The City of Lake Elmo  
Planning Commission will conduct a meeting on  
**Monday November 26, 2018**  
**at 7:00 p.m.**  
**AGENDA**

**AGENDA ITEM:** Royal Golf Club at Lake Elmo 3<sup>rd</sup> Addition Final Plat and Planned Unit Development (PUD) Plans and Easement Vacation

**WYNDHAM VILLAGE**  
**LAKE ELMO, MINNESOTA**  
 GRADING, DRAINAGE & EROSION CONTROL PLAN

**Updated Final Plat**

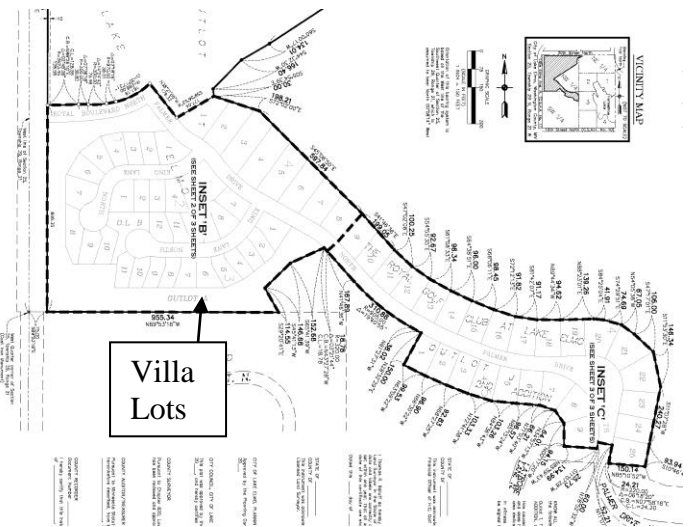
**Consistency with Preliminary Plat.** The proposed lot sizes, widths, and proposed impervious surface are generally consistent with that of preliminary plat. The only change is the modification of Kings Lane which was shown as a loop road in the Preliminary Plat, and is now proposed as two cul-de-sacs in the Final Plat. As a result of the conversion to two cul-de-sacs, forty original villa lots fronting Kings Lane have been reduced to 33 villa lots. General circulation is maintained in the broader development with through-traffic along Palmer Drive.

**Street Design.** As shown on the 3<sup>rd</sup> Addition Final Plat the Applicant has proposed to reconfigure the ‘loop’ road and instead develop two cul-de-sacs to serve the lots within the 3<sup>rd</sup> Addition. Both cul-de-sacs as shown meet the City’s ordinance requirements for cul-de-sac length, required right-of-way and cul-de-sac terminus. This change is generally consistent with the lot types shown on the Preliminary Plat and the cul-de-sacs do not change the character of the Plat.

**C2.1**

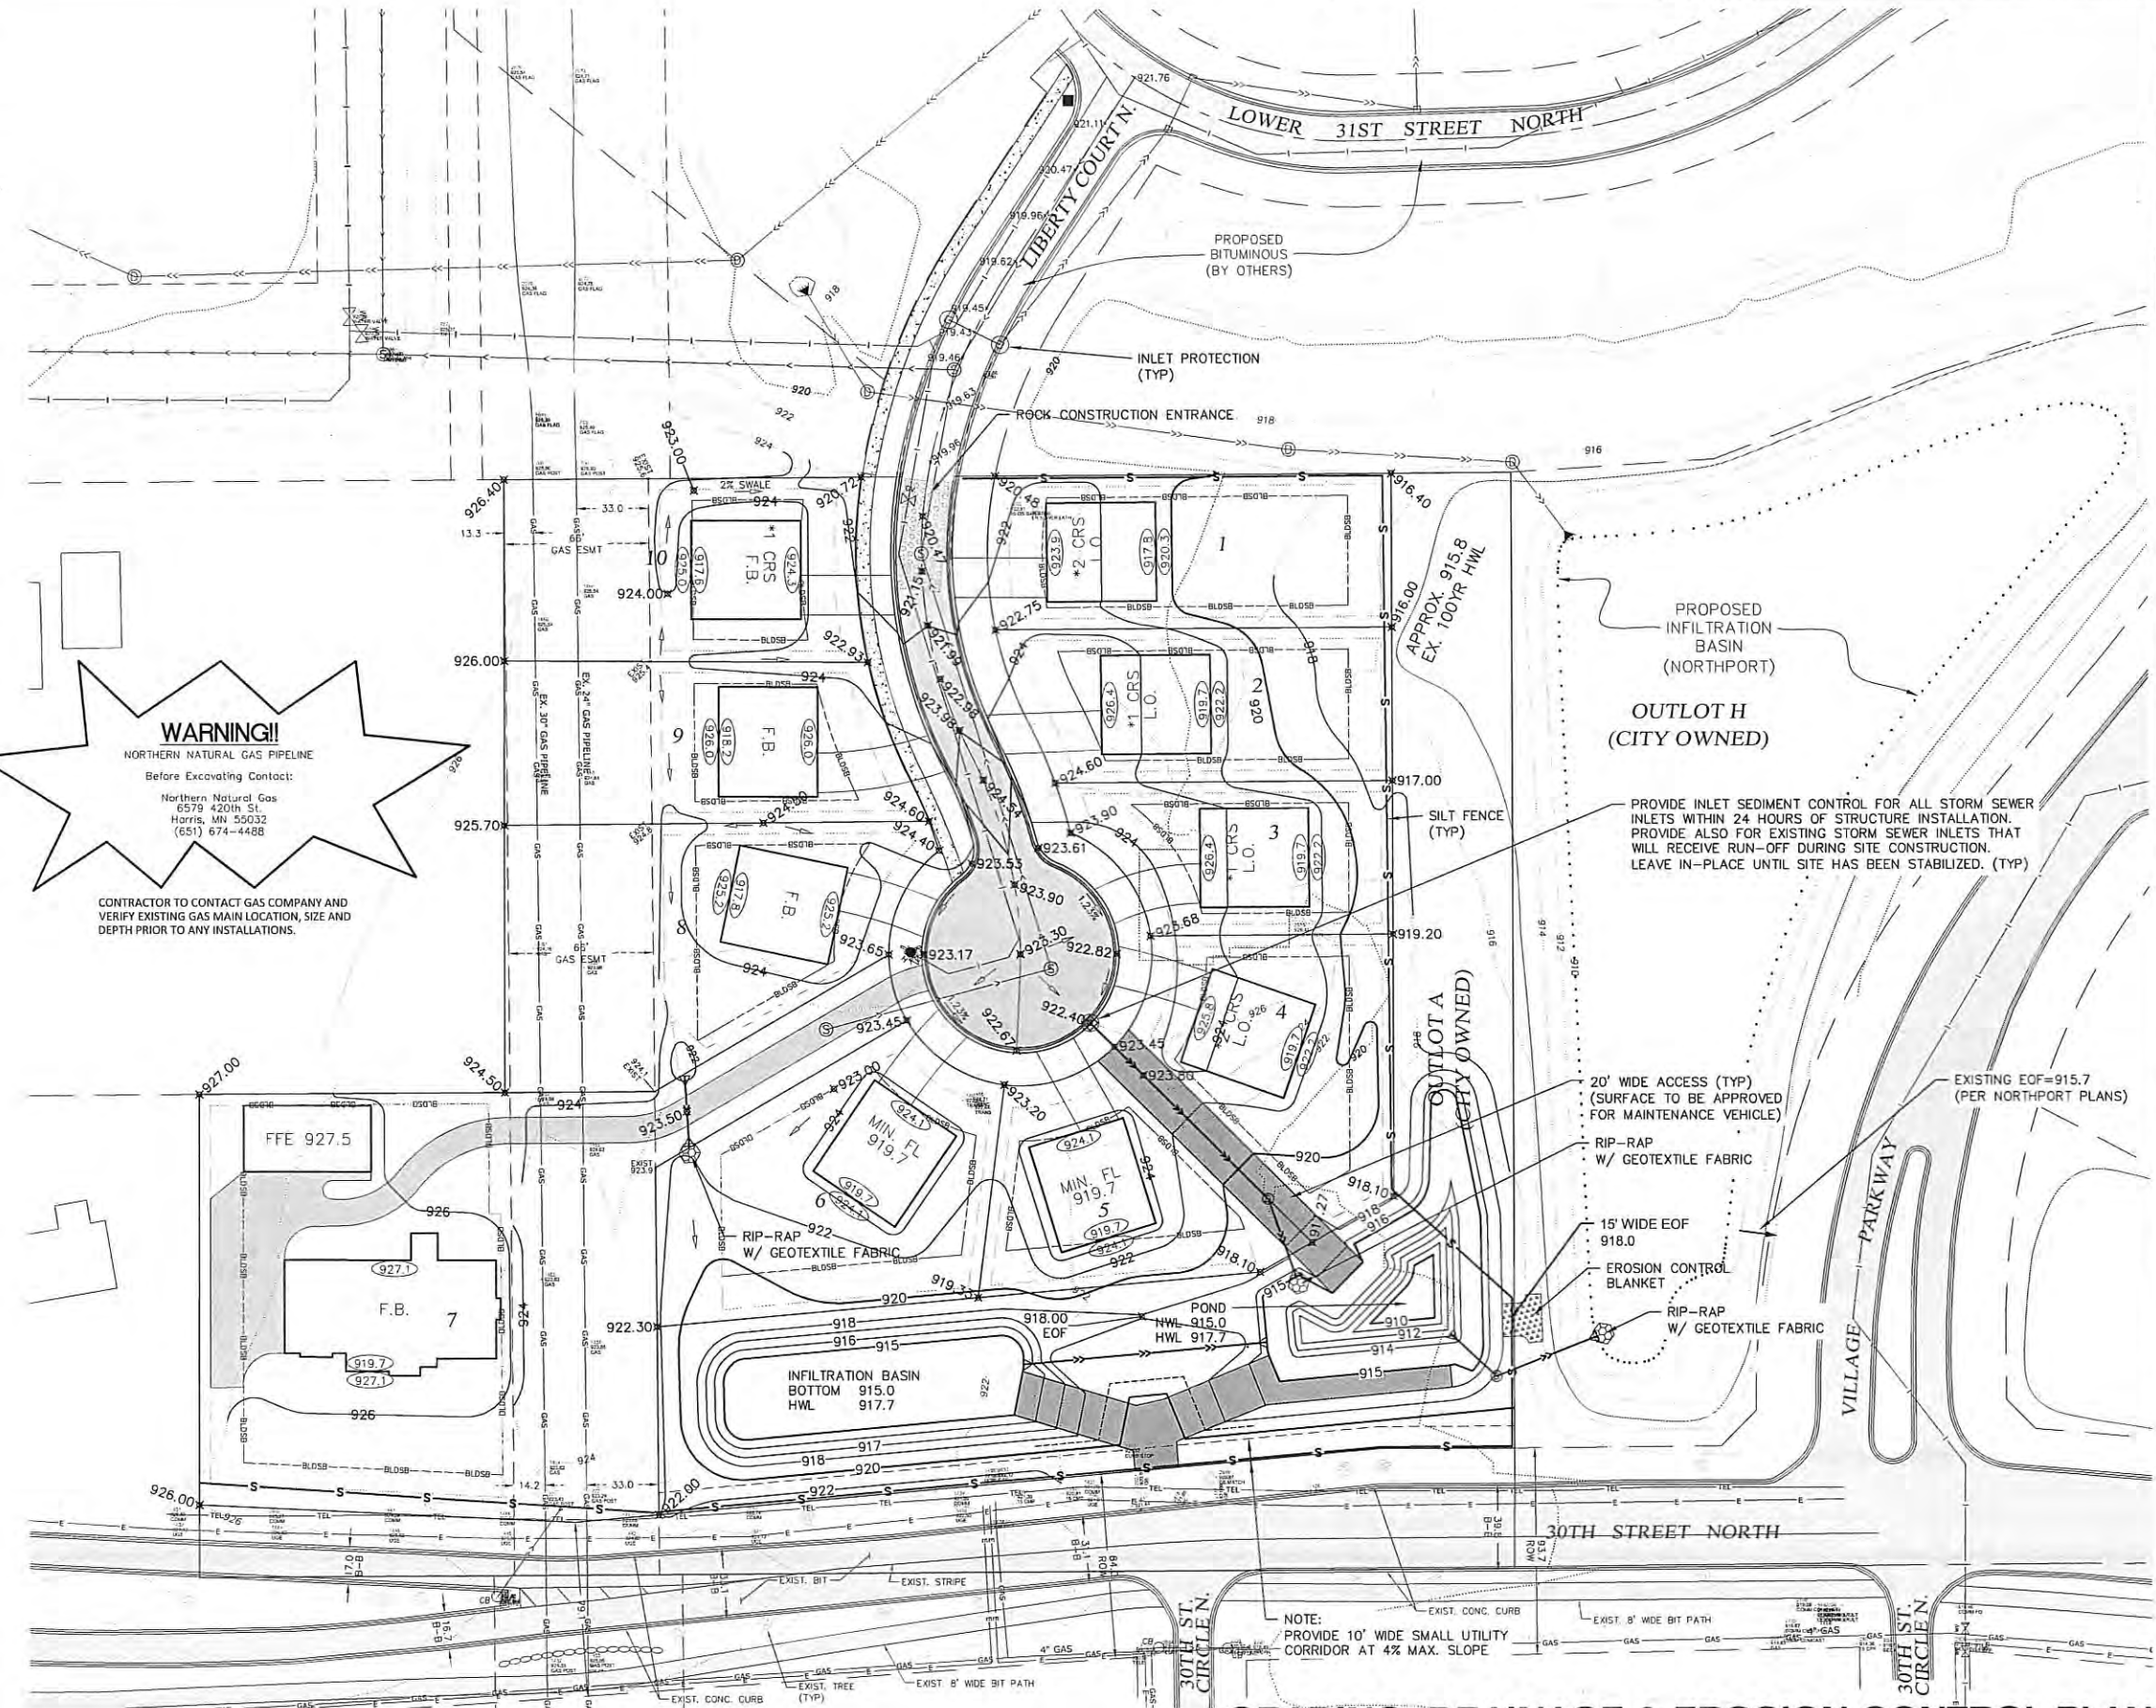
- C1.1. and C2.1. The random survey shots must be removed from the plans to facilitate a complete review. If specific shots are intended to inform the design, the text size and placement must be legible.

- C1.1 and C2.1. Correct all overlapping text so that the plans are legible.
- C2.1. All low floor elevations must be a minimum of 2-feet above the pond HWL to meet VBWD rules. All low openings must be a minimum of 1-foot above the adjacent emergency overflow elevations. The low floor for Lot 1 may need to be revised.

- C2.1. Revise the grading for the Stormwater Pond to comply with the Minnesota Stormwater Manual configuration recommendations. At the current size/configuration the pond is not likely to perform well and could be a nuisance to adjacent properties.

- C2.1. The grading plan is incomplete around Lot 7, Block 1. Existing conditions (trees and other physical features) and existing contours are required to the north and west of Lot 7. The grading plan must be detailed for Lot 7 to demonstrate matching into existing conditions and directing drainage away from adjacent properties.

- C2.1. The rear lot drainage and utility easements must be increased for Lots 8, 9, and 10, Block 1 to cover the proposed drainage swales per the grading plan. Lots 8 & 9 must be 15 feet and Lot 10 must be 10 feet.

- C2.1. Correct grading at FES-8 (invert 921.0) by extending the 922.0 contour to the north of the invert. Extend the 920.0 contour to maintain a minimum ditch slope of 2%.

- C2.1. Add plan notes to provide storm water pond liner construction requirements consistent with the VBWD pond lining material and testing requirements.

- C2.1. Add plan notes for infiltration basin construction requirements including basin protection and testing.
- C2.2. Label both FES for the equalizer pipe.

WYNDHAM VILLAGE  
LAKE ELMO, MINNESOTA  
SANITARY SEWER AND WATER  
PLAN & PROFILE

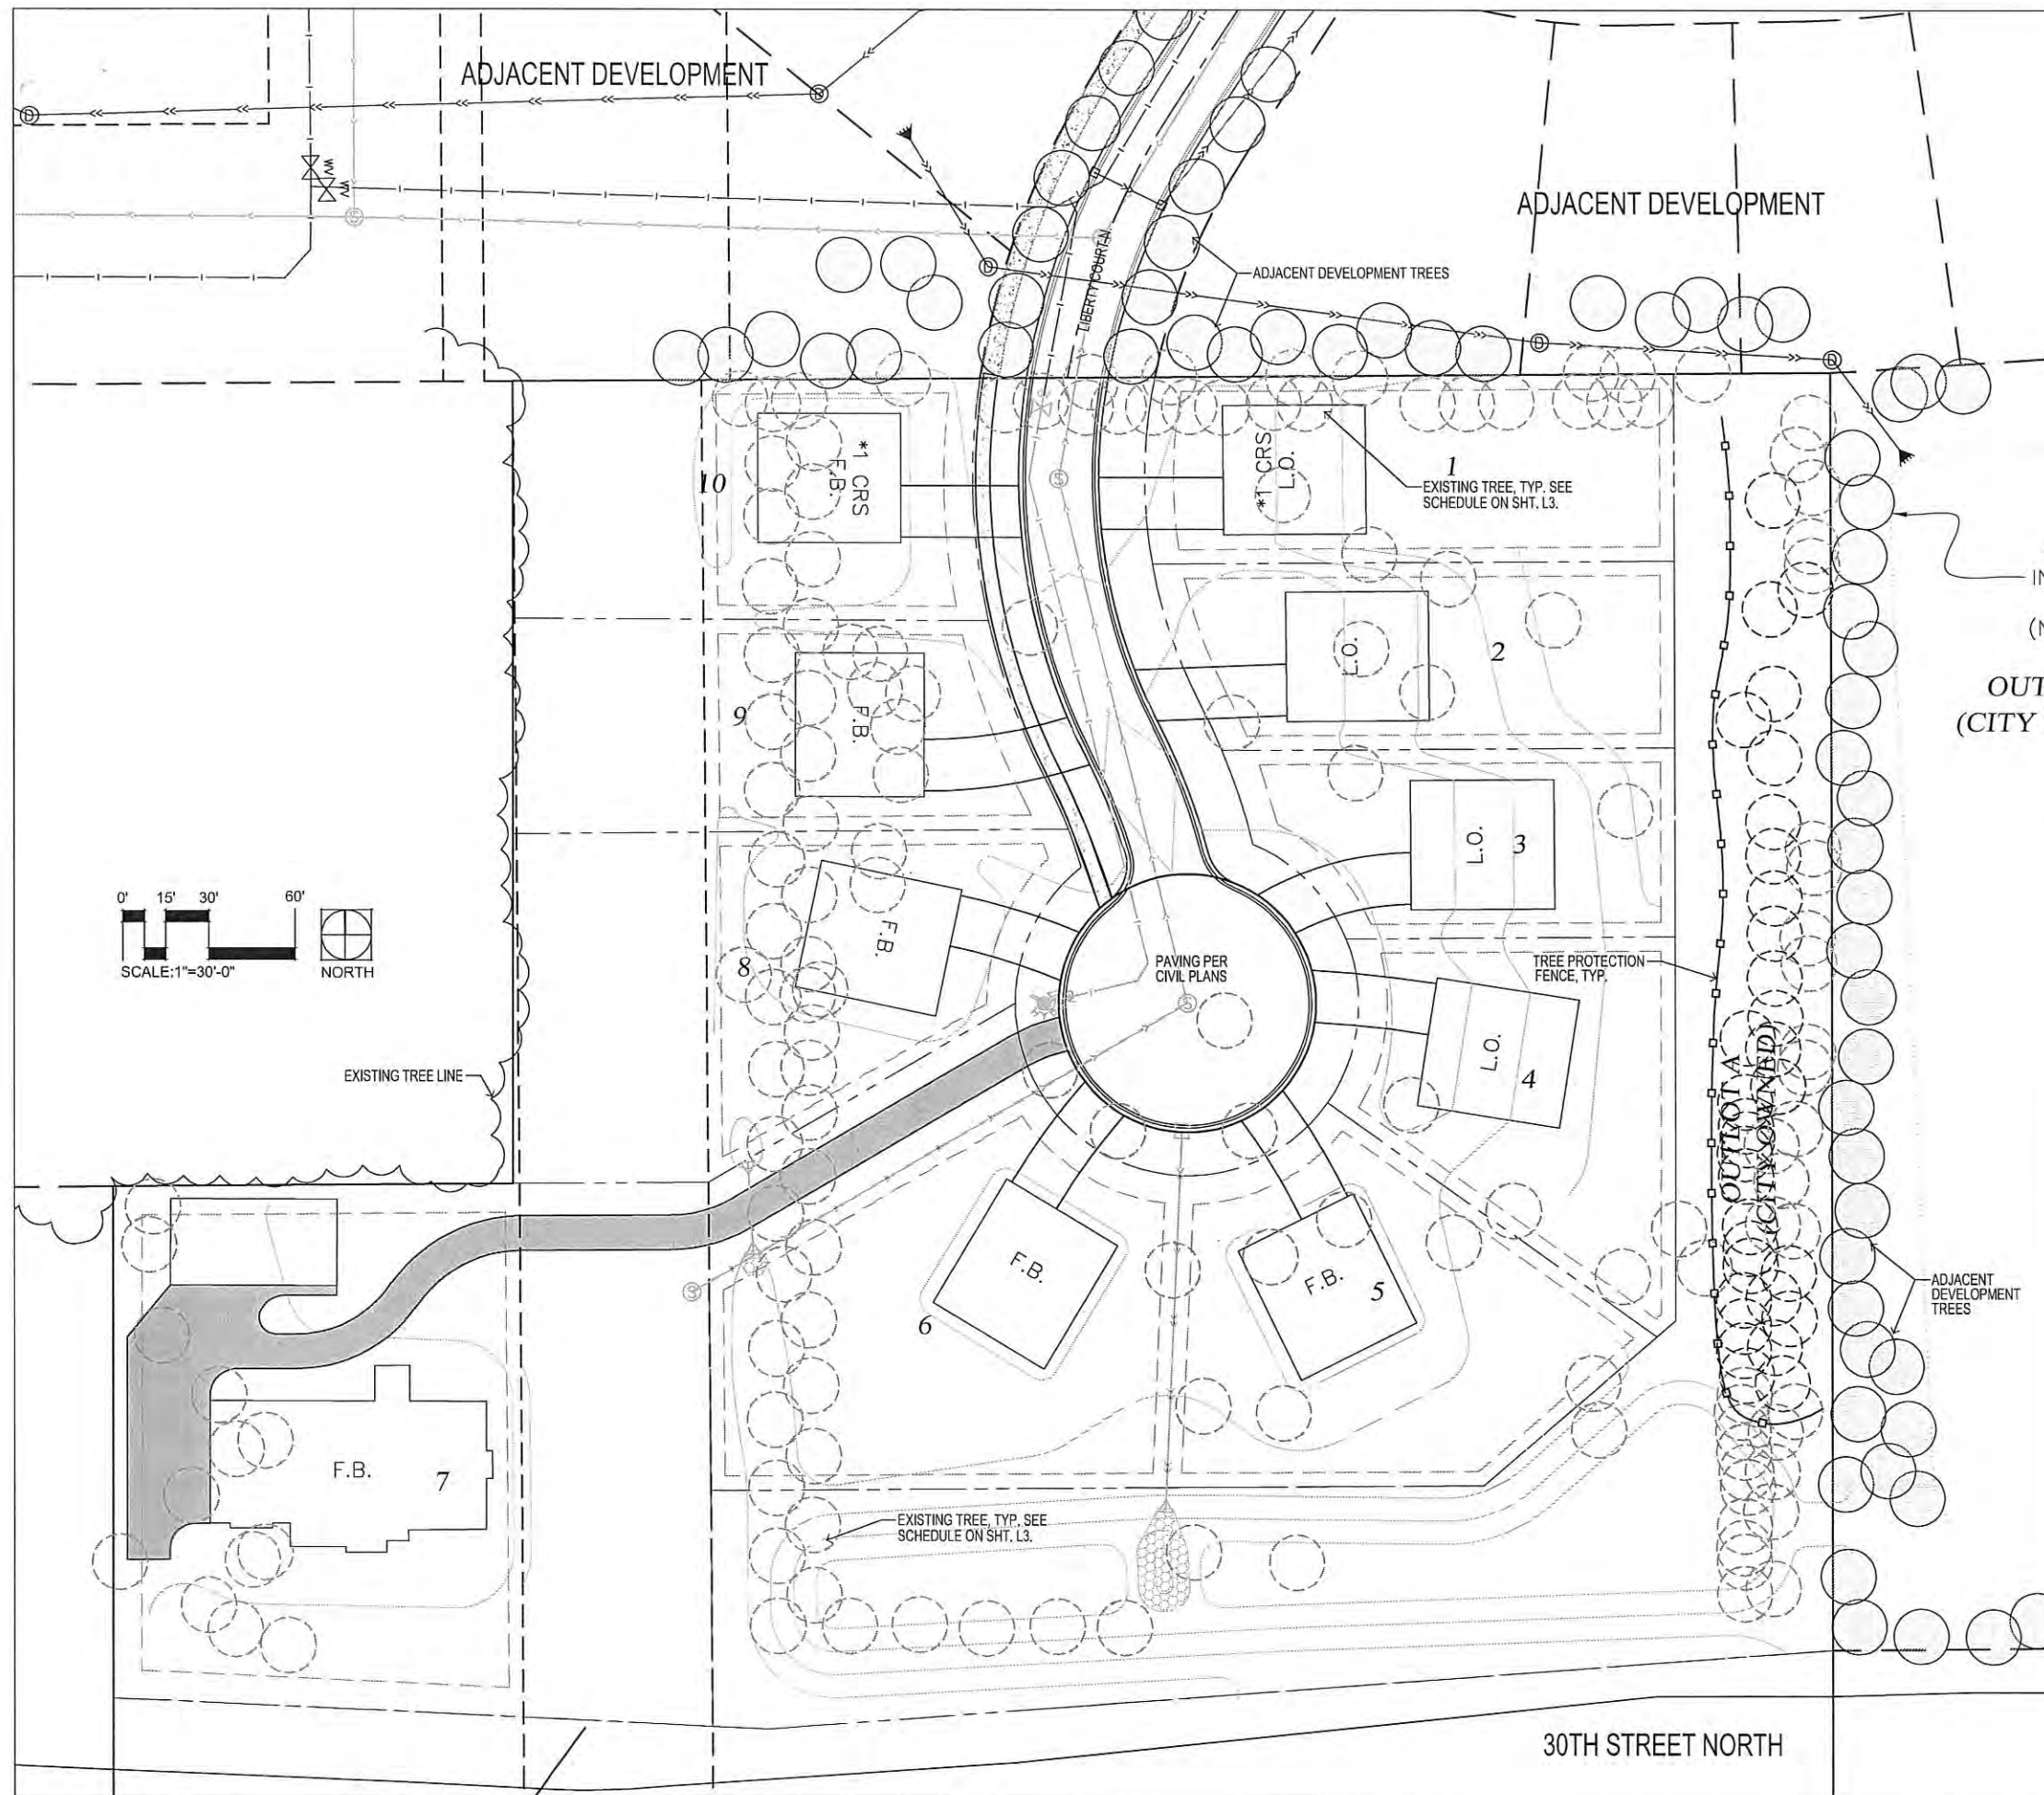
- C2.2. Add draintile out of CB1 for a minimum distance of 100-feet each way. Add drain tile connection inverts in profile to CB1.
- C3.1 and 3.2. "Proposed MH-1" should be shown as an "Existing MH-1" in both plan and profile views and on both plan sheets. As-built invert elevations must be shown. Remove all references to "Proposed by Others".

- C3.2. Revise plan for all water services to be upstream of the sanitary sewer service.
- C3.2. Move view port to show the service ends for Lot 7.
- C3.2. Water service to Lot 7 is greater than 100 feet (the limited length for a roll of copper). Revise service to install curb box at the R/W with HDPE service pipe extended to the west of the gas easement with a second curb stop.

- C3.2. Add wye stationing, sanitary service invert elevation and curb stop elevation for Lot 7.
- C3.2. Provide call outs indicating size and type of all watermain bends.
